John S. Keenan  
Vice President  
Brunswick Nuclear Plant

BRUNSWICK STEAM ELECTRIC PLANT, UNIT NOS. 1 AND 2  
DOCKET NOS. 50-325 AND 50-324/LICENSE NOS. DPR-71 AND DPR-62  
REVISION TO PLANT EMERGENCY PROCEDURE

OPEP-02.6.28, "Off-Site Protective Action Recommendations," Revision 7:

**OPEP-02.6.28*****OFF-SITE PROTECTIVE ACTION  
RECOMMENDATIONS***

ATTACHMENT 1  
Page 1 of 1  
PAR Flowchart

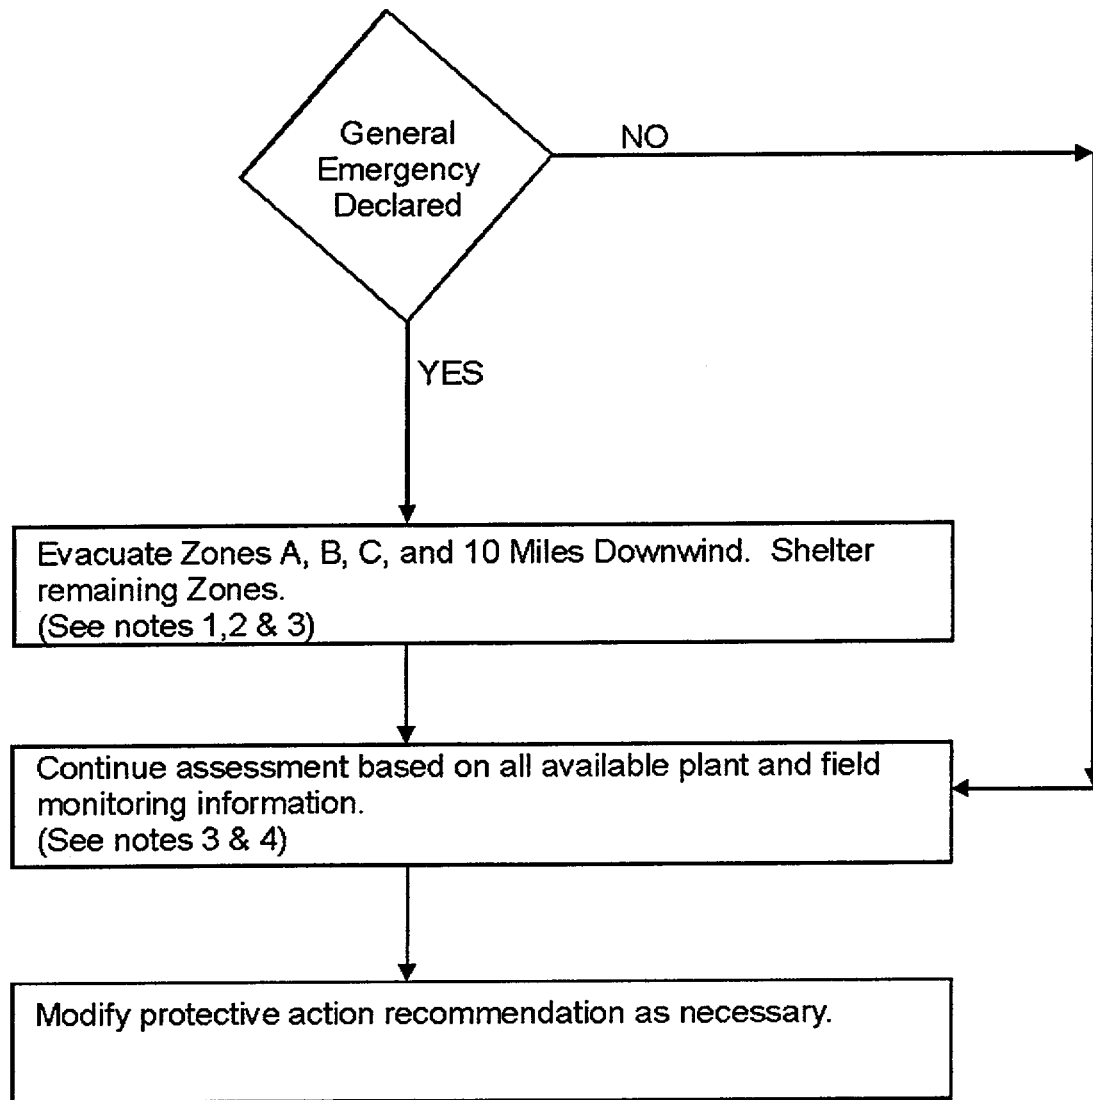
1. Revised Section 2.0 to add a reference to NUREG-0654, Revision 1, Supplement 3;
2. Clarified instructions for making initial Protective Action Recommendations (PARs); and
3. Revised Attachment 1, "PAR Flowchart," to be consistent with NUREG-0654 guidance.

- Revised references list to include NUREG-0654, Rev. 1 Supp. 3.
- Revised procedure section to direct making initial PAR based on Plant Conditions, consistent with NUREG guidance.
- Modified PAR logic diagram to be consistent with NUREG guidance.
